Private Fuel Storage, L.L.C.

**SUBMITTAL OF COMMITMENT RESOLUTION LETTER #7 INFORMATION
DOCKET NO. 72-22 / TAC NO. L22462
PRIVATE FUEL STORAGE FACILITY
PRIVATE FUEL STORAGE L.L.C.**

ENCLOSURE NO. 1 – GEOTECHNICAL PROGRAM
COMMITMENT RESOLUTION LETTER NO. 7 – JUNE 30, 1999

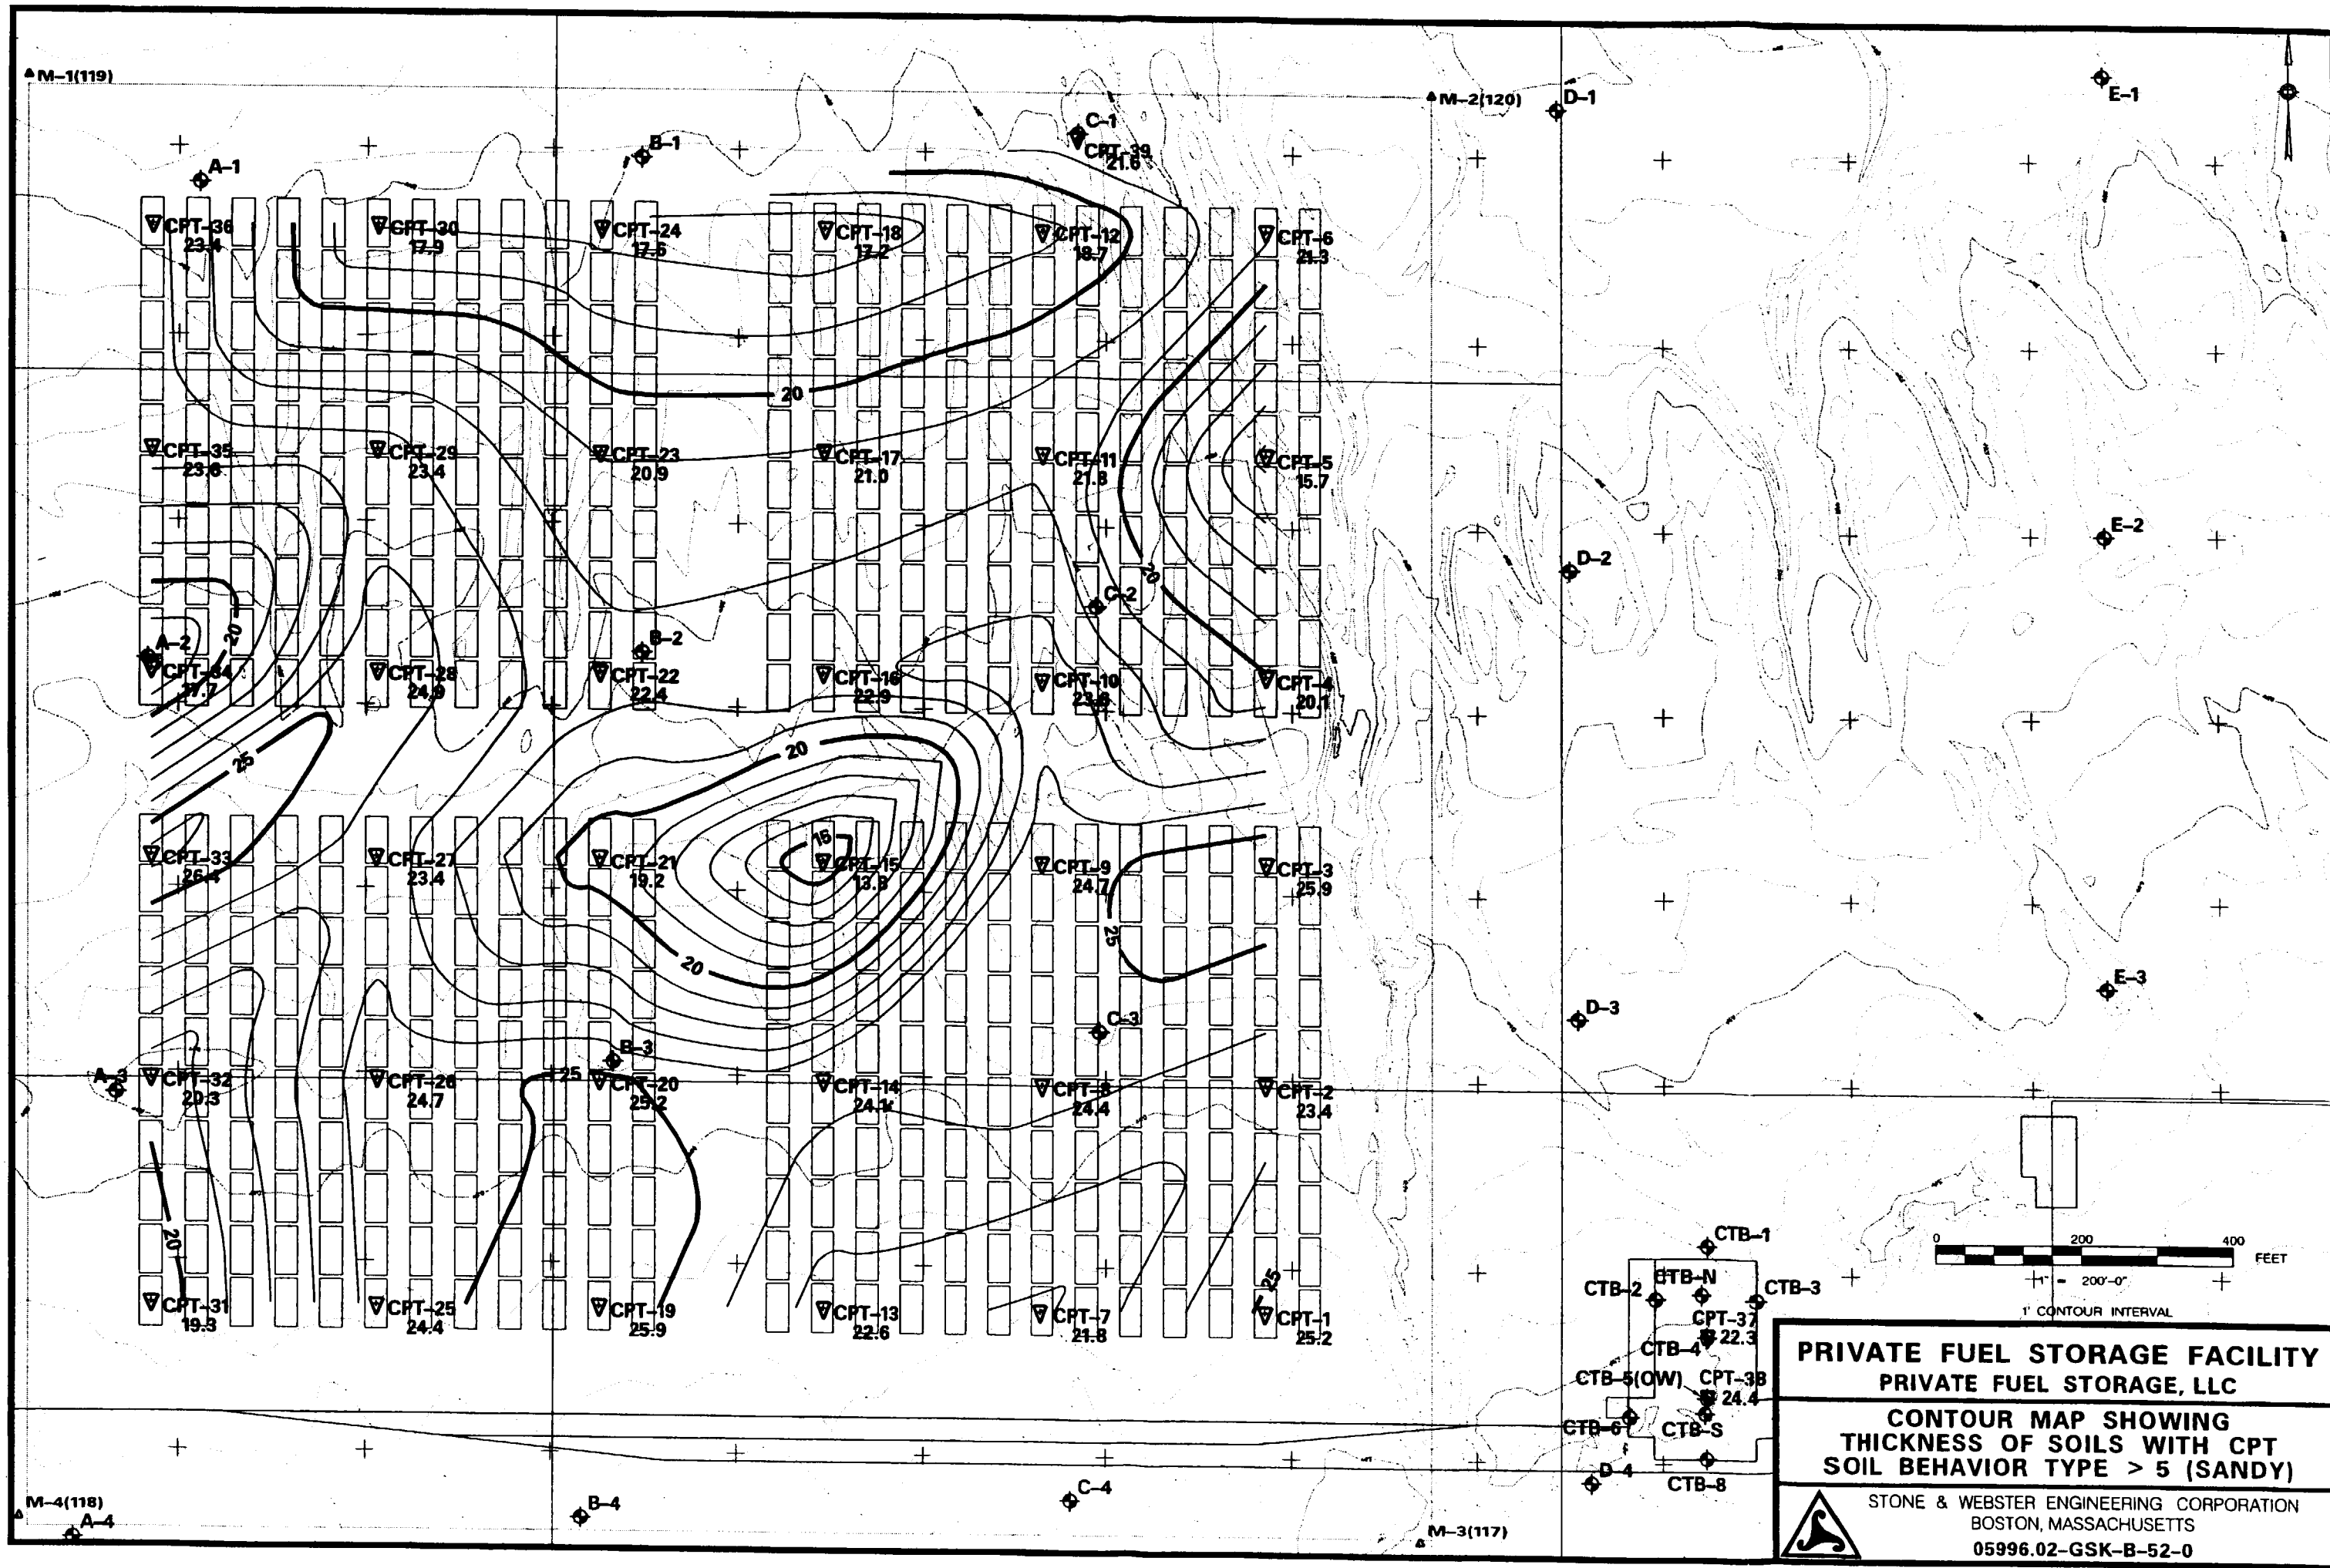
Item 1: The cone penetrometer testing (CPT) data that PFS submitted on May 28, 1999 (ConeTec, 1999) indicates that the soil classifications based on the CPT data include sandy silts, silty sands, and sands in the upper 25 to 30-ft layer, where PFS previously has reported that this layer consists of uniform silt, silty clay, and clayey silt. PFS should develop a map showing the areas where the sandier soils exist.

The purpose of the request that PFS provide a map showing the areas where the sandier soils exist was to readily identify those areas where the subsurface profile differs from the assumption that the soils in the upper layer (~25 to 30 ft) are predominantly cohesive. A review of the CPT data (ConeTec, 1999) indicates that most of the soil behavior type (SBT) values represent soils whose behavior is similar to that of "sandy" soils. As indicated in Figure 5 of ConeTec (1999), these include SBT values that are greater than 5. Therefore, to respond to Item 1, PFS generated a map showing the thickness of those soils for which the behavior type values are greater than 5.

This map, titled "Contour Map Showing Thickness of Soils with CPT Soil Behavior Type > 5 (Sandy)" is included as Attachment 1. The thickness of the soils beneath the cask storage pads that behave as "sandy" soils based on the CPT data are posted under the CPT identifiers shown on this plan view of the site. These values were calculated by subtracting the top three feet, to account for the proposed depth of the pads, as well as the total thickness of all zones where the SBT value was found to be less than 6, from the total depth of the CPT. The

thicknesses were contoured to facilitate interpretation of the $SBT > 5$ data obtained in the CPT program. As indicated in the figure, the thickness of the soils that behave as sandy soils ($SBT > 5$) based on the CPT data ranges from 13.8 feet at CPT-15, near the center of the pad emplacement area, to a high of 26.4 feet at CPT-33 near the center of the western edge of the pad emplacement area. The thicknesses are generally about 20 to 25 feet.
